Bridge Design Engr.	M:\PRELIMINARY PLANS\I-5 EVERETT HOV LANES\BRIDGE 5-633 E\5-633E P4.MAN							
Supervisor	11/26/05 ADDENDUM #5			REGION NO.	STATE	FED. AID PROJ. NO.	SHEET NO.	TOTAL SHEETS
Designed By				10	WASH.			
Checked By				JOB NUMBER				
Detailed By Andersen, JM 07/04								
Bridge Projects Engr.								
Prelim. Plan By Hsieh, JC 07/04								
Architect/Specialist	DATE	REVISION	BY	APP'D

I-5 EVERETT
SR 526 TO SR 2 HOV LANES

GNRY 36TH ST OC BRIDGE NO. 5/633E WIDENING

BRIDGE SHEET NO. 5 OF SHEETS

SECTION ~ NEAR PIER 4

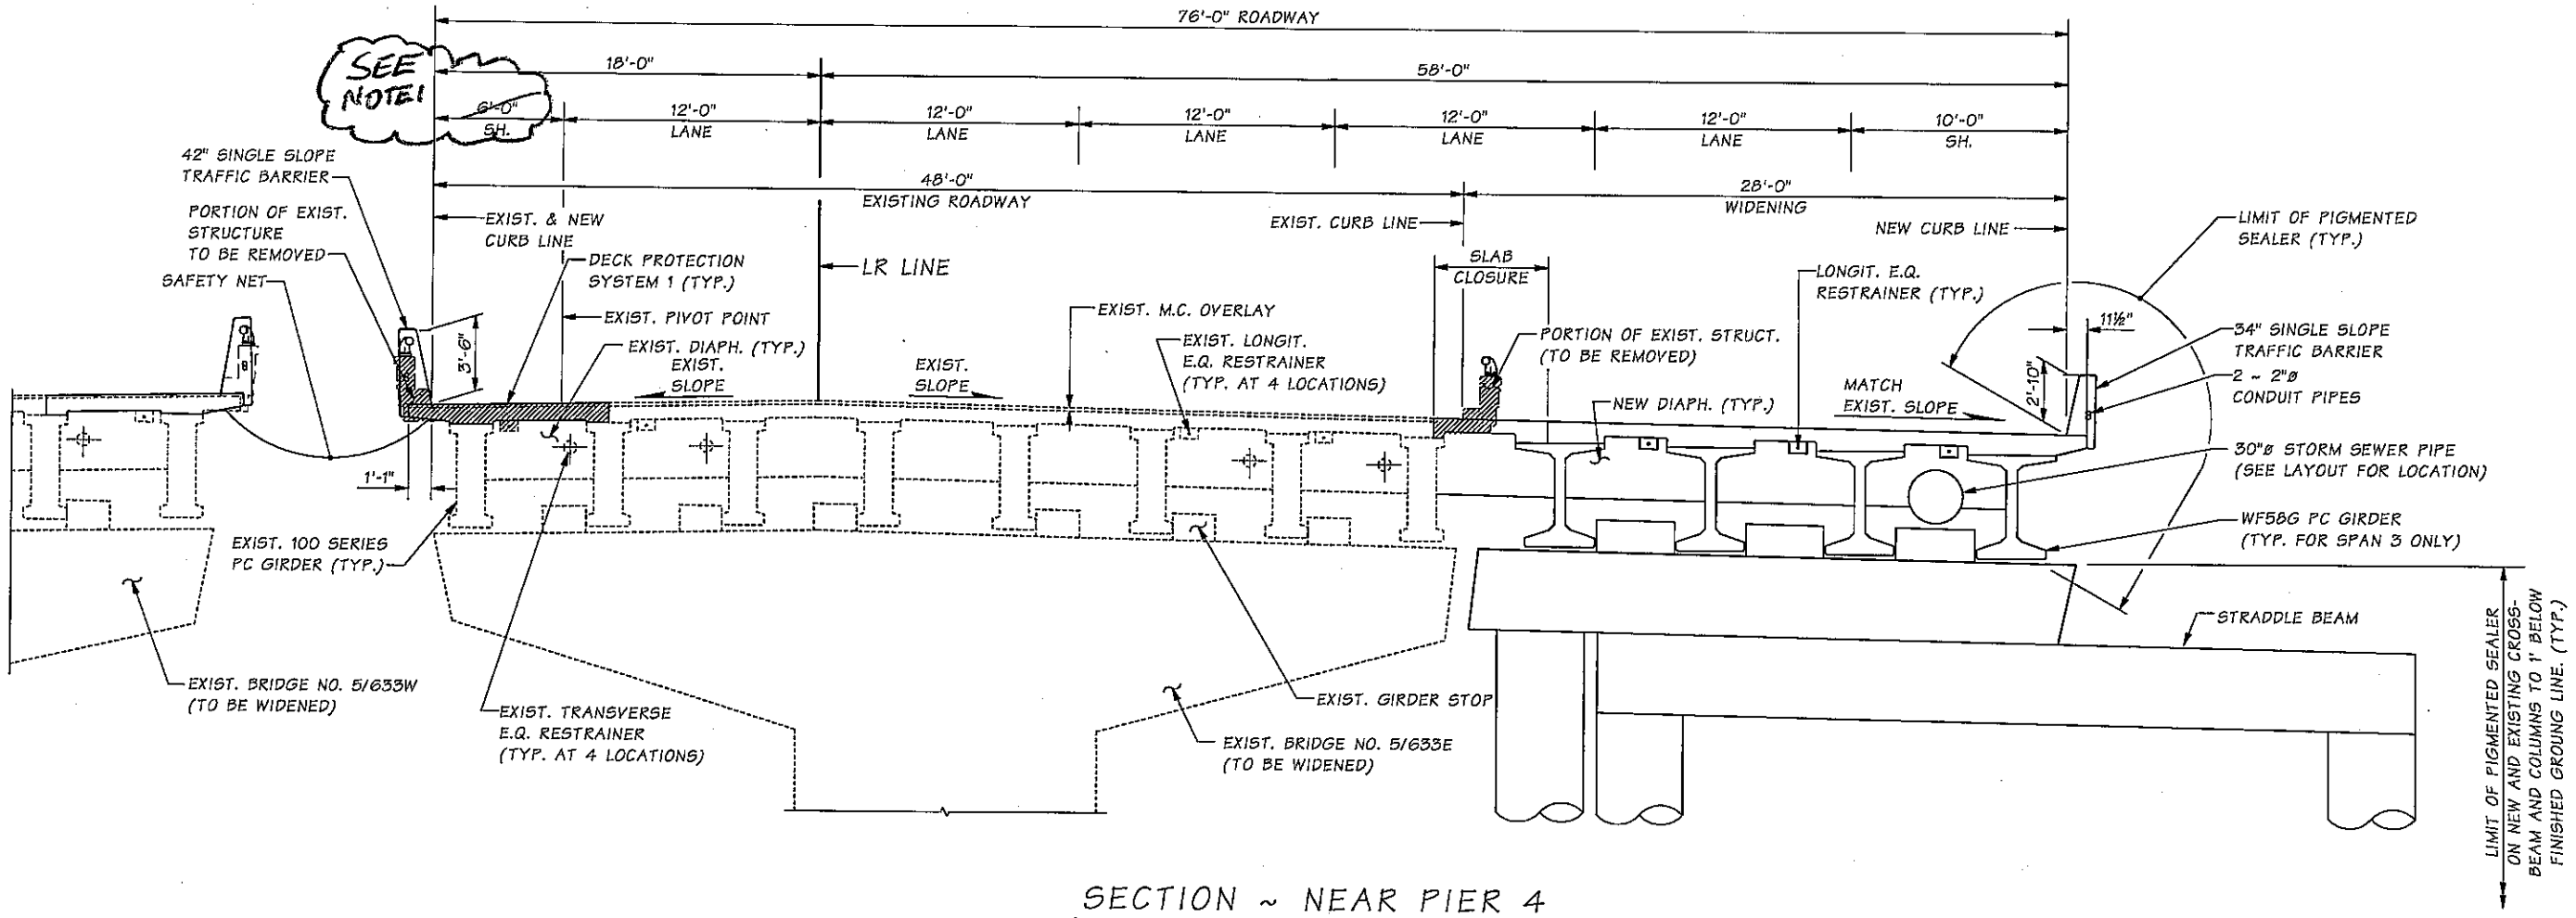
NOTE 1: WSDOT CONCEPTUAL DESIGN OF 5/633E INCORRECTLY INDICATES A 6'-0" INSIDE SHOULDER. DESIGN-BUILDER SHALL CORRECT THIS TO 8'-6" TO COMPLY WITH THE APPROVED DEVIATION IN APPENDIX M3.
